# Errata Sheet

October 16, 2001 / Release 1.0

**Device:** SAB-C167CS-L16M 3V  
SAF-C167CS-L16M 3V

**Stepping Code / Marking:** ES-BA, BA 6

#### **New value of the PLL jitter**

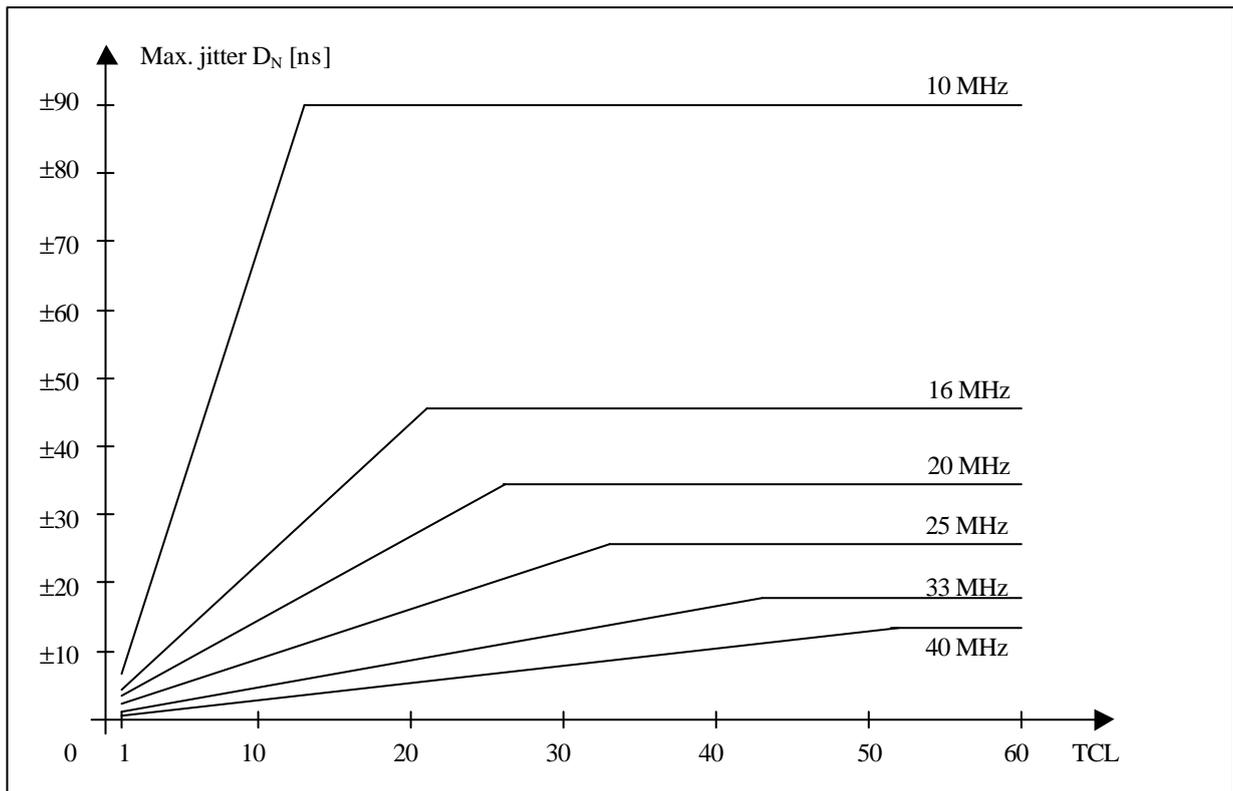
In systems where the PLL is used for generation of the CPU clock frequency, the PLL jitter can increase under certain circumstances and exceed the specified value.

The value of the additional jitter is not a fixed one but it depends on the kind of activity on the external bus or output pins. The additional jitter increases with the number of output/bus pins which are switched at the same time to a new voltage level because the problem is caused by noise on the on-chip power supply.

The additional jitter has the maximum effect if only one TCL is considered (period jitter). This can have an influence to the bus timings with one TCL.

The additional jitter decreases with the number of consecutive TCLs (accumulated jitter). The accumulated jitter has an effect on timings with more than one TCL (certain bus timings, CAN bus timing, serial interface).

For an accumulated period of  $N \cdot \text{TCL}$  the new maximum jitter  $D_N[\text{ns}]$ , which exceeds the specified value in the Data Sheet, is computed using the formula:

$$D_N[\text{ns}] = \pm((460 / f_{\text{CPU}} + 4366 / f_{\text{CPU}}^2) * (N / T_m) + 0.25)$$

Were  $N$  = number of consecutive TCL,  $f_{\text{CPU}}$  = CPU frequency in MHz and  $T_m = f_{\text{CPU}} * 1.3$ .

This approximated formula is valid for a CPU frequency  $10 \text{ MHz} \leq f_{\text{CPU}} \leq 40 \text{ MHz}$  with the conditions:

$$\begin{aligned} T_m &= f_{\text{CPU}} * 1.3 && \text{for } N \leq T_m \\ T_m &= N && \text{for } N > T_m \end{aligned}$$
